ATTACHMENT I TO IPN-90-046

PROPOSED TECHNICAL SPECIFICATION CHANGES
RELATED TO
PRESSURE-TEMPERATURE LIMITS

NEW YORK POWER AUTHORITY
INDIAN POINT 3 NUCLEAR POWER PLANT
DOCKET NO. 50-286
DPR-64

SAFETY EVALUATION
RELATED TO
PRESSURE-TEMPERATURE LIMITS
TECHNICAL SPECIFICATION CHANGES

FIGURE 3.1-1

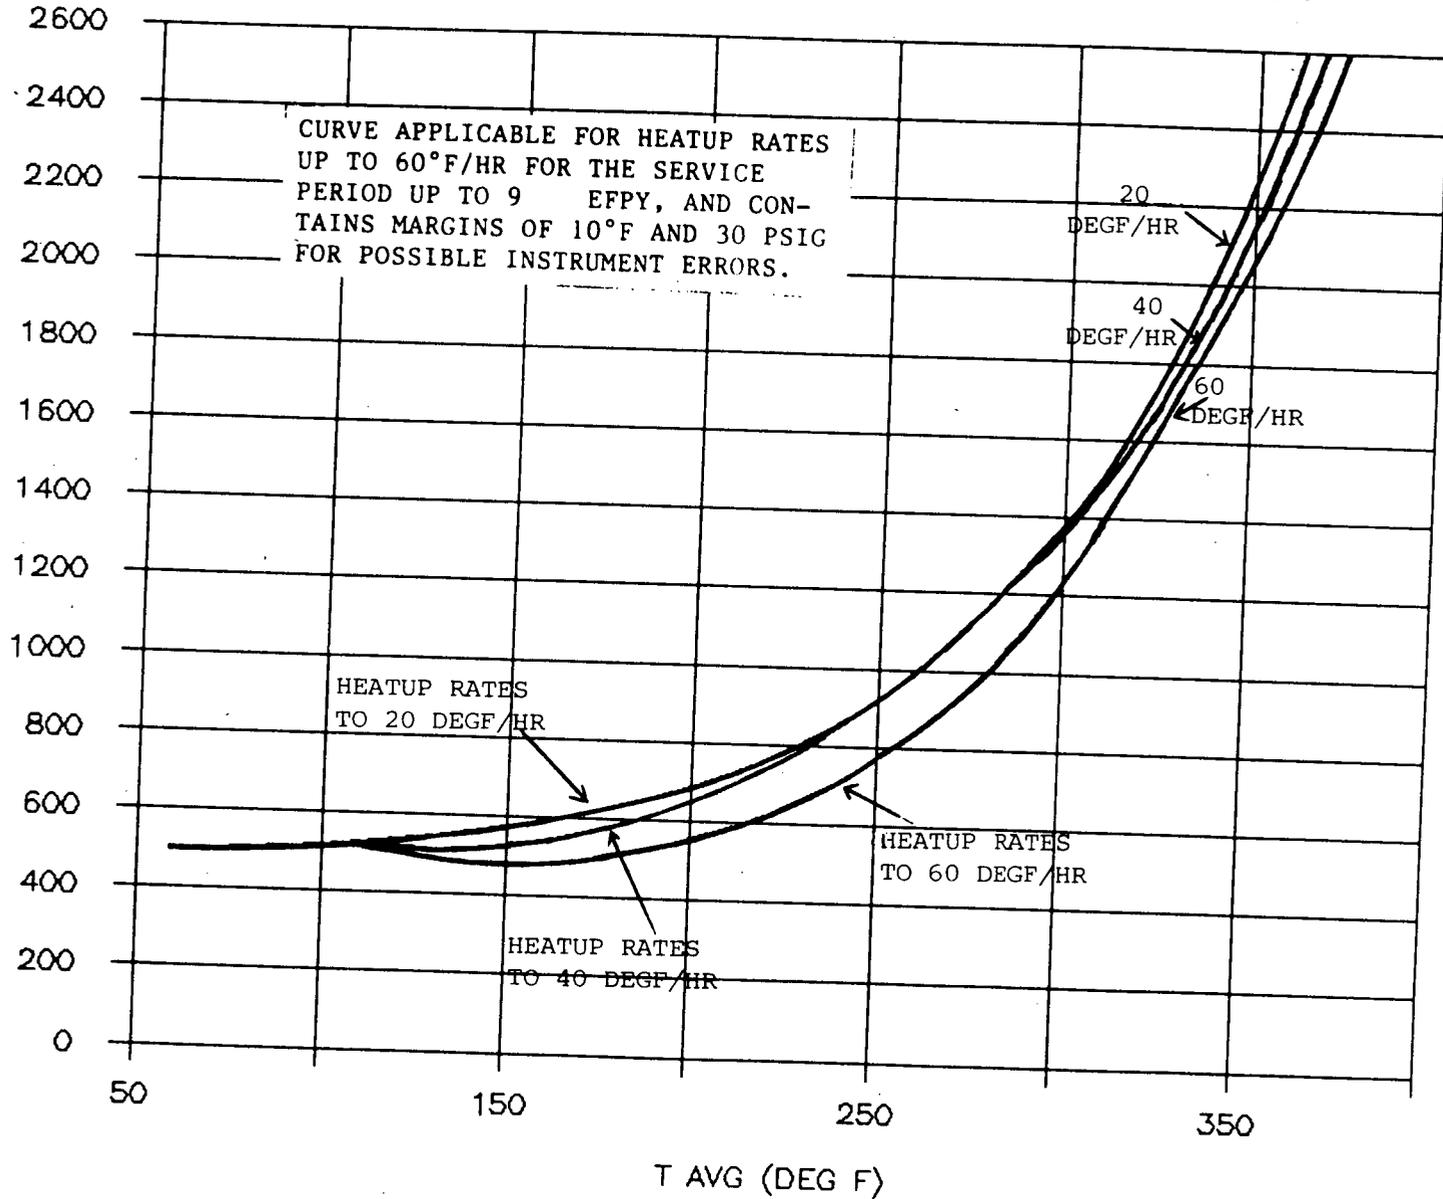
1. The reactor coolant temperature and pressure and system heatup and cooldown rates averaged over one hour (with the exception of the pressurizer) shall be limited in accordance with Figure 3.1-1 and Figure 3.1-2 for the service period up to 9.00 effective full-power years (EFPYs). The heatup and cooldown rates shall not exceed 60°F/hr and 100°F/hr respectively.

The first reactor vessel material surveillance capsule was removed during the 1978 refueling outage. This capsule has been tested by Westinghouse Corporation and the results have been evaluated and reported ⁽⁷⁾. Based on the Westinghouse evaluation, heatup and cooldown curves (Figures 3.1-1 and 3.1-2) were developed for up to 9.26 EFPYs of reactor operation.

Generic Letter 88-11 requested that licensees use the methodology of Regulatory Guide 1.99, Revision 2, "Radiation Embrittlement of Reactor Vessel Materials", to predict the effect of neutron radiation on reactor vessel materials as required by paragraph V.A. of 10 CFR part 50, Appendix G. Capsule Z was analyzed ⁽⁸⁾ and new pressure-temperature curves were developed using this methodology.

The maximum shift in RT_{NDT} after 9.00 EFPYs of operation is projected to be 194°F at the 1/4 T and 157°F at the 3/4 T vessel wall locations for Plate B2803-3, the controlling plate. Plate B2803-3 was also the controlling plate for the first operating period of 2 EFPYs.

Generic Letter 88-11 requested that licensees use the methodology of RG 1.99, Revision 2, "Radiation Embrittlement of Reactor Vessel Materials," to predict the effect of neutron radiation on reactor vessel material. In accordance with the requirements of RG 1.99, Revision 2, and in keeping with the methodologies described therein, a series of heatup and cooldown curves have been developed for Indian Point 3. The heatup curves cover a range of heatup rates from 20 °F/hr through 60 °F/hr, and the cooldown curves a range from 0 °F/hr (isothermal) to 100 °F/hr.

FIGURE 3.1-2

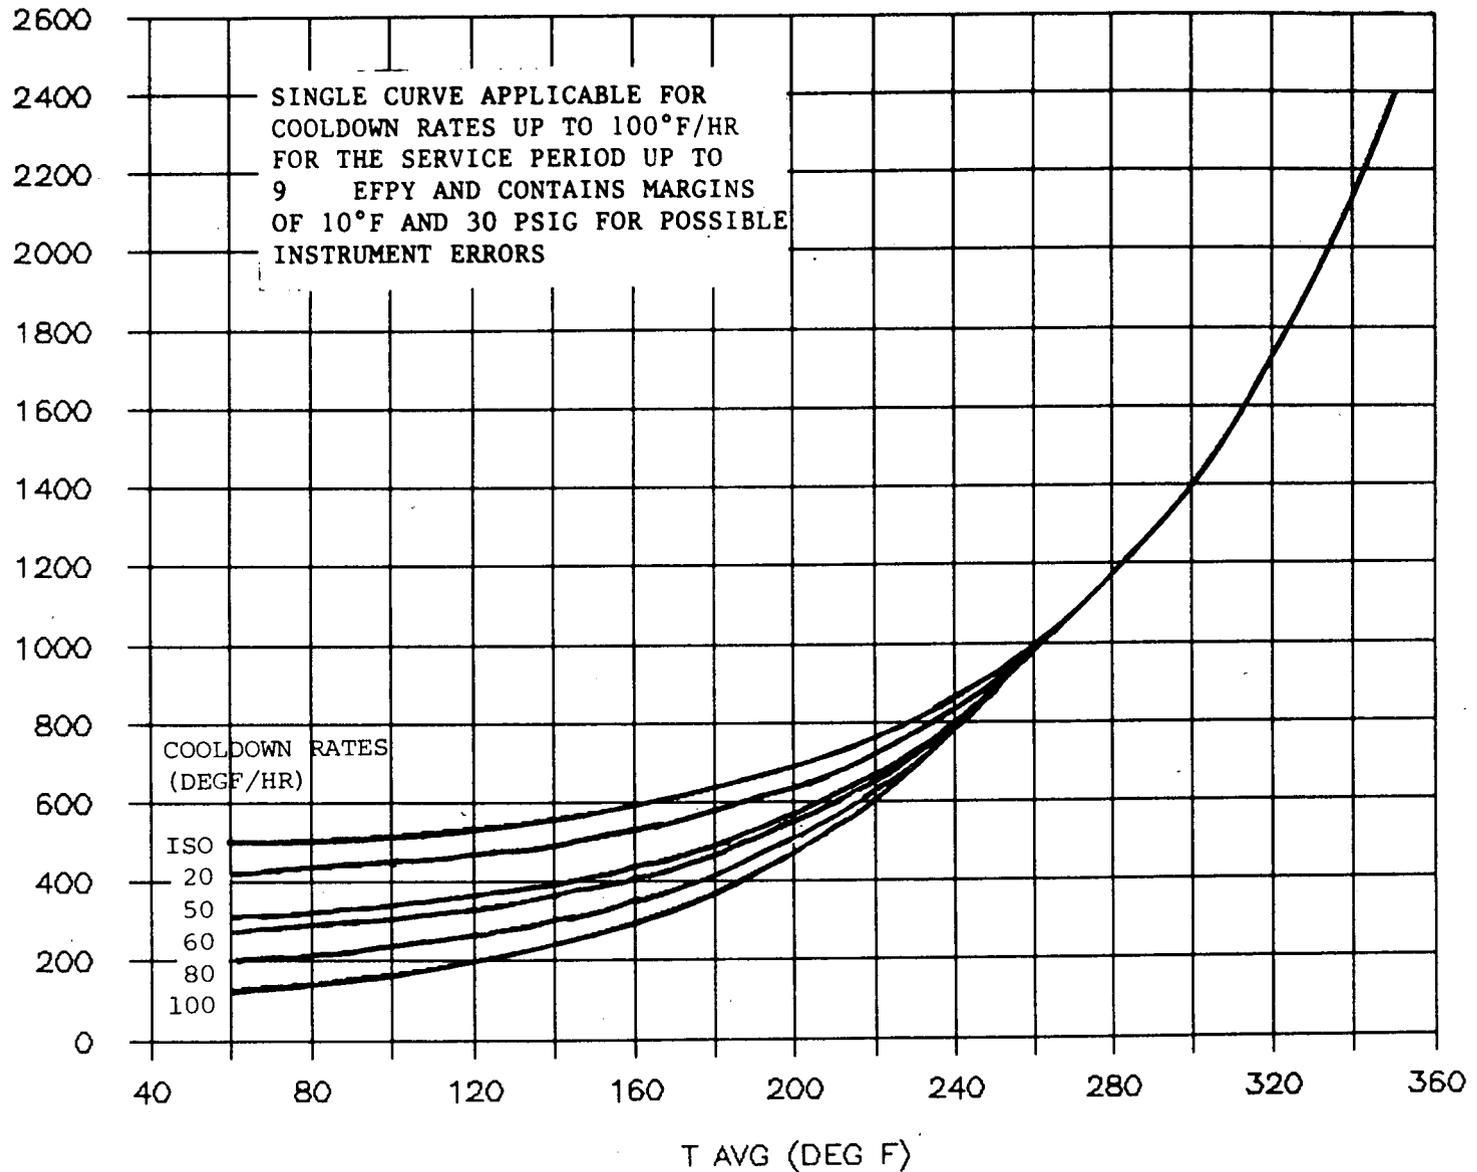
Because operation control is on coolant temperature, and cooldown rate may vary during the cooldown transient, the limit curves shown in Figure 3.1-2 represent a composite curve consisting of the more conservative values calculated for steady state and the specific cooling rate shown.

FIGURE 4.3-1, PRESSURE/TEMPERATURE

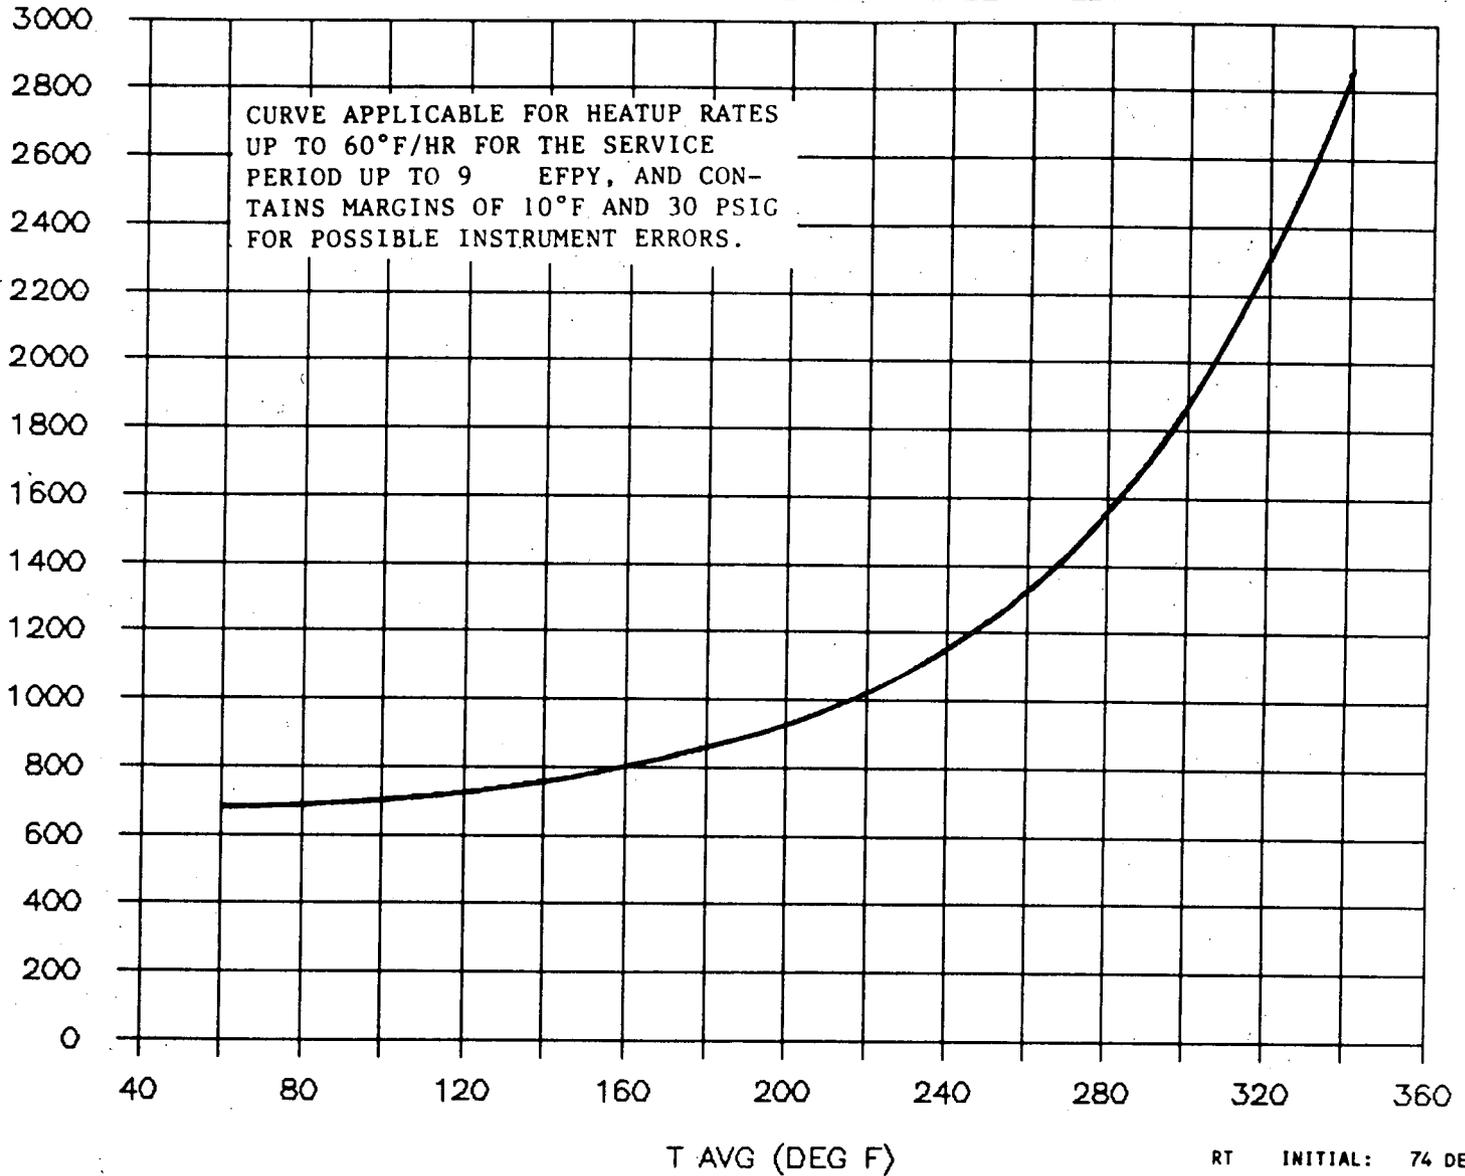
The inservice leak test temperatures are shown on Figure 4.3-1. The temperatures are calculated in accordance with ASME Code Section III, Appendix G. This Code requires that a safety factor of 1.5 times the stress intensity factor caused by pressure be applied to the calculation.

For the first 9.00 effective full power years, it is predicted that the highest RT_{NDT} in the core region taken at the 1/4 thickness will be 194°F. The temperature determined by methods of ASME Code Section III for 2335 psig is 135°F above this RT_{NDT} and for 2510 psig (maximum) is 145°F above this RT_{NDT} . The minimum inservice leak test temperature requirements for periods up to nine effective full power years are shown on Figure 4.3-1.

The heatup limits specified on the heatup curve, Figure 4.3-1, must not be exceeded while the reactor coolant system is being heated to the inservice leak test temperature. For cooldown from the leak test temperature, the limitations of Figure 3.1-2 must not be exceeded. Figures 4.3-1 and 3.1-2 are recalculated periodically, using methods discussed in the Basis for Specification 3.1.B and results of surveillance specimens, as covered in Specification 4.2.
